PLANNING REPORT - Major Site and Building Plan Review and CUP

RE: Sunfish Lake – 45 Salem Church Road – Site and Building Plan Review
and CUP

Memorandum

Re: *Site and Building Plan Review
45 Salem Church Road
City of Sunfish Lake, MN
WSB Project No. 02182-090*

CERTIFICATE OF SURVEY

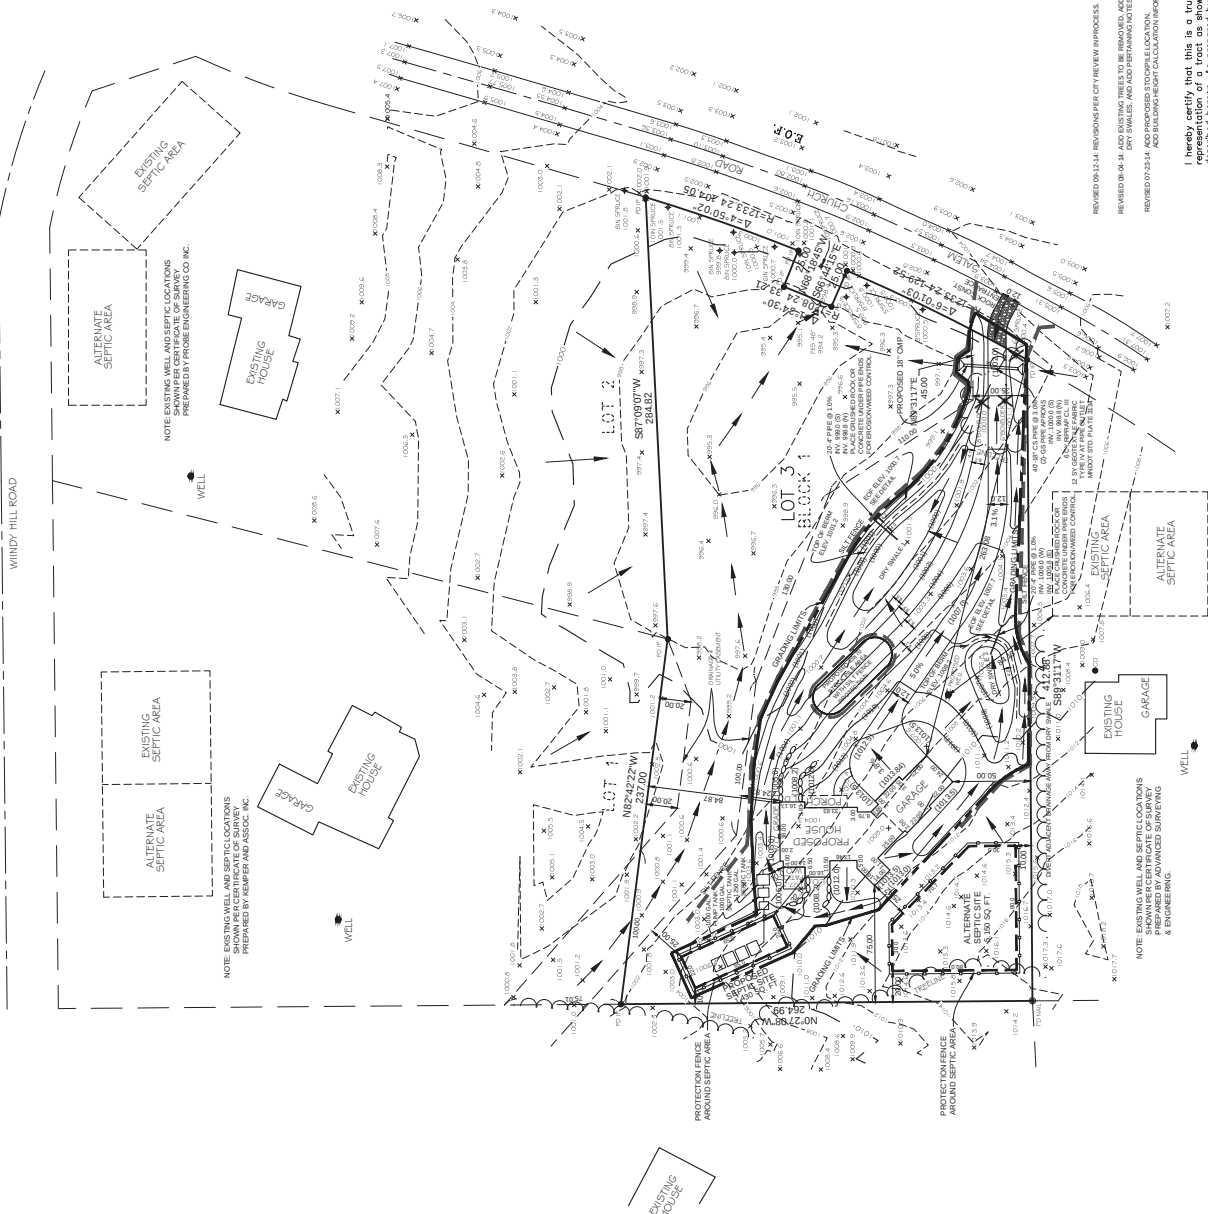
- There appears to be several retaining walls around the house. Please provide top and bottom of wall elevations. The builder/applicant must provide retaining wall plans for review for any wall that are 4-feet in height or taller including the 2 tiered wall on the backside of the house. These will need to be designed and signed by a registered professional engineer in the State of Minnesota.

- The grading plan is missing contour elevations on several contours. Please label.
- The City requires 5(H):1(V) slopes, however for this site, we are willing to allow 3:1 slopes in the swale areas only. It appears that many slopes along the drainage swales are 2:1. Please revise as necessary.

- Per the Site Plan Checklist the building height shall be calculated as follows: The building height limitation shall be determined by taking the average existing grade of the structure and adding thirty (30) feet. The existing grade shall be determined by taking spot elevations at all points around the perimeter of the house and finding the average. The building height as measured on the elevation drawings shall be the distance between the top of foundation and peak of the roof which when added to the top of foundation elevation may not exceed the building height limitation as defined above.

- Additional berms along the south side property line may be required to ensure water stays onsite and goes into the proposed drainage swales. This condition may be required during construction if the site appears not to drain to the swales.

- Most of tree survey shots are labeled, but show the tree symbols on the site plan. Also add a note

- to protect all trees that are to remain.
- Several pine and other significant trees are along the south and west property lines. These should be surveyed and grading along this property line must protect these trees and their drip lines. Showing just a tree line is not sufficient.
- The tree line along the southeast corner does not appear to be accurate and several trees appear to be missing and should extend at least 25-feet into the south property. Tree impacts to the south property must be minimized (grading into the drip lines, etc.).
- The residents to the south and west will likely be concerned with the trees along the property lines and care must be taken during any removals of trees on the 45 Salem Church Road property not to damage existing trees on the adjacent properties. A note on the plan should be added stating this.
- See the attached aerial for more details.

- The existing 48-inch culvert under Salem Church Road should be shown with inverts label on each side.
- Add culvert protection on the inlet side of this culvert as necessary to prevent sediment from getting into the City culvert.

- The existing well on the west property must be surveyed and be at least 50-feet away from the septic drain field. Please show this on the plans.

- The type of paving material should be shown on the plans with the dimension of the width of the driveway shown at the street connection.
- The Contractor must adhere to axel load limits when delivering material to the site.
- Any damage to Salem Church Road and City right-of-way shall be repaired to the City's satisfaction by the applicant prior to the issuance of a certificate of occupancy. It is recommended the builder take pictures of the roadway prior to construction to document the condition of the roadway. These pictures should be taken at a wide enough angle to verify their location.

CASAGRANDE RESIDENCE
LANDSCAPE 2014
45 SALEM CHURCH ROAD
SUNFISH LAKE, MN
HANDY HELD ESTATES
LOT 3, BLOCK 1

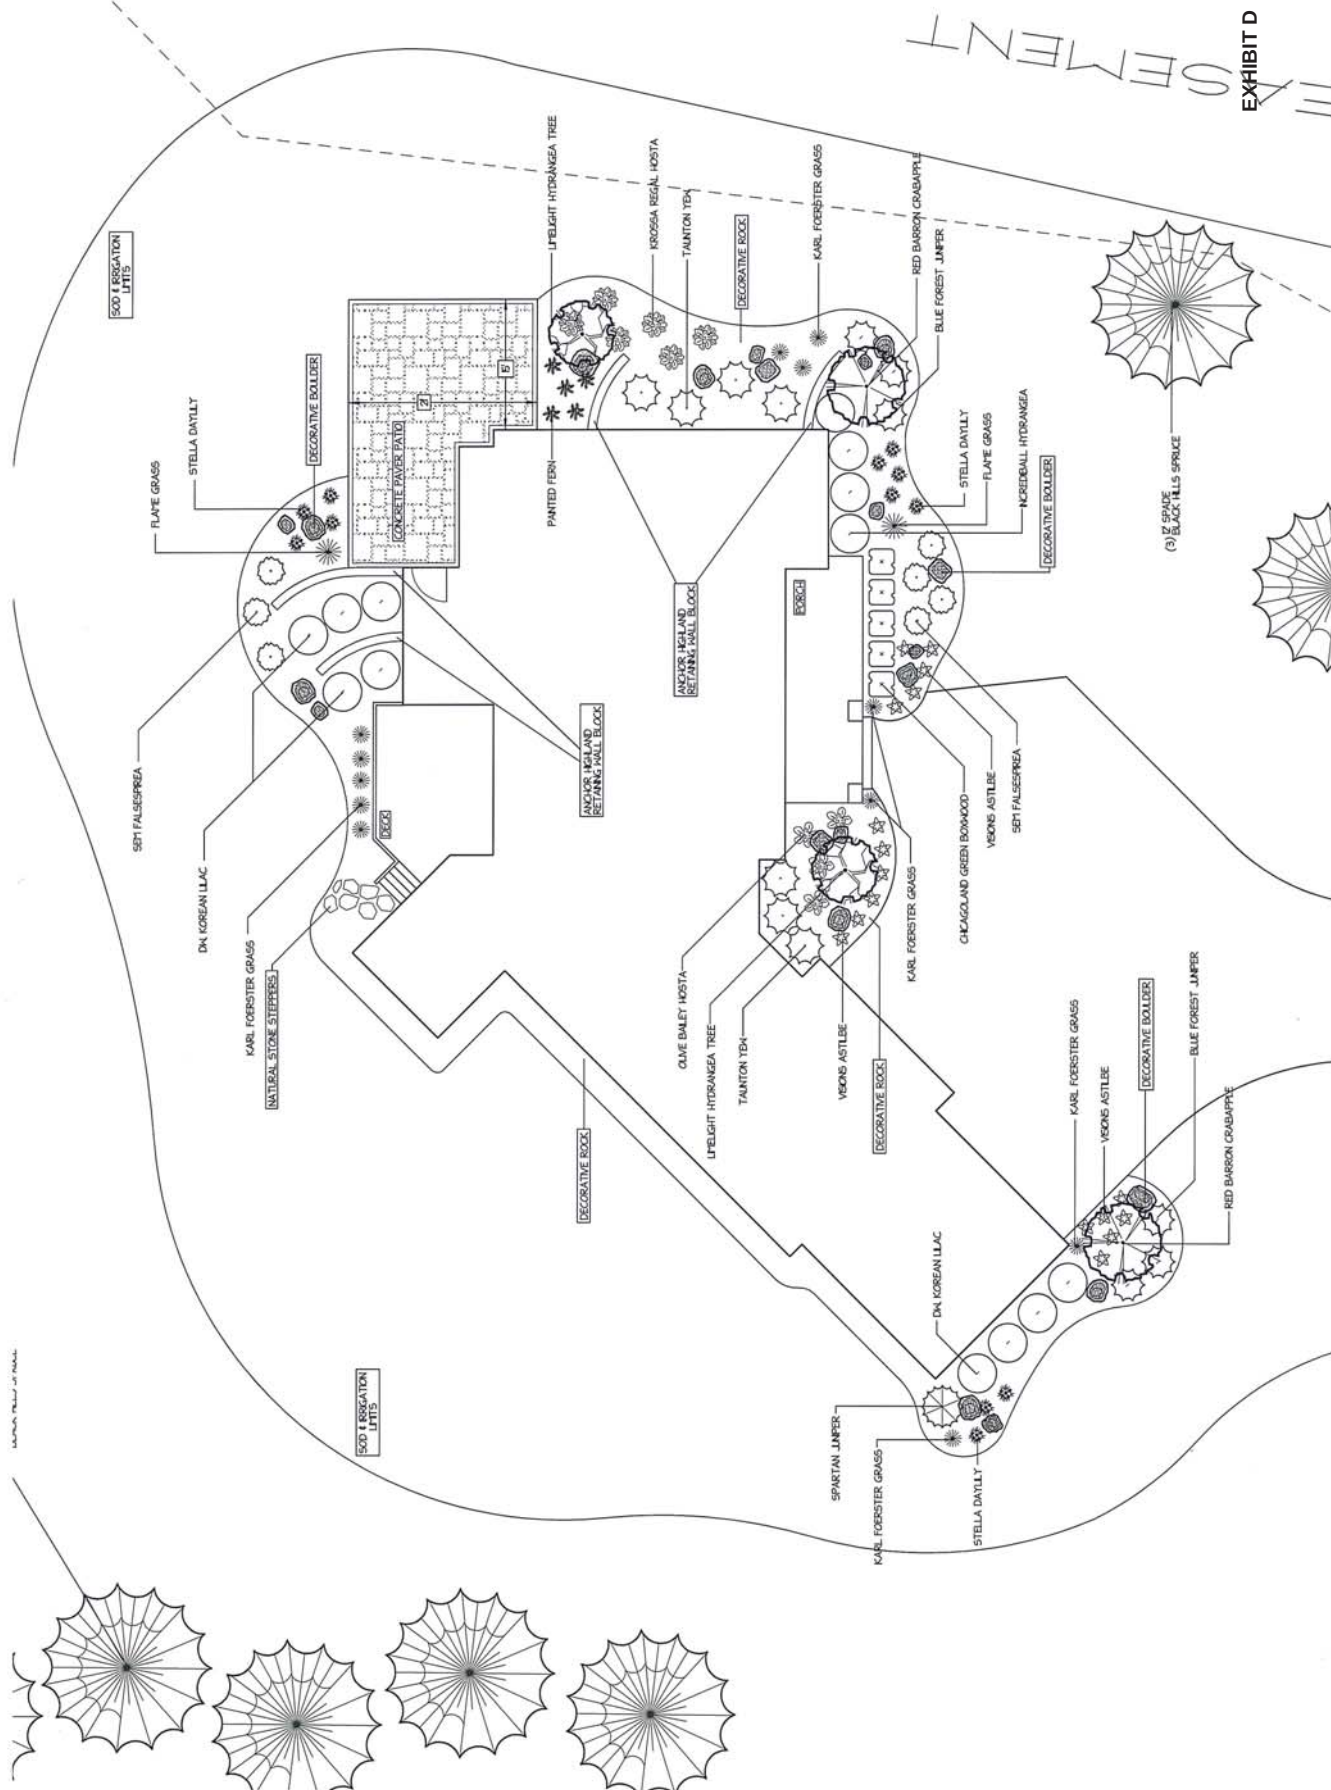
Trees to be planted in areas to the east and south of the home appear to help screen the garage and proposed lighting from adjacent properties and the road. Lighting on the north side of the home near the patio may be visible to the property to the north given a lack of tall trees or shrubs in that area. An additional tree or tall shrubs should be installed north of the patio in the vicinity of proposed lighting, to reduce the impact of illumination out from the described light fixture.

2. An additional tree or tall shrubs should be installed north of the patio in the vicinity of proposed lighting, to reduce the impact of illumination out from the proposed light fixture.
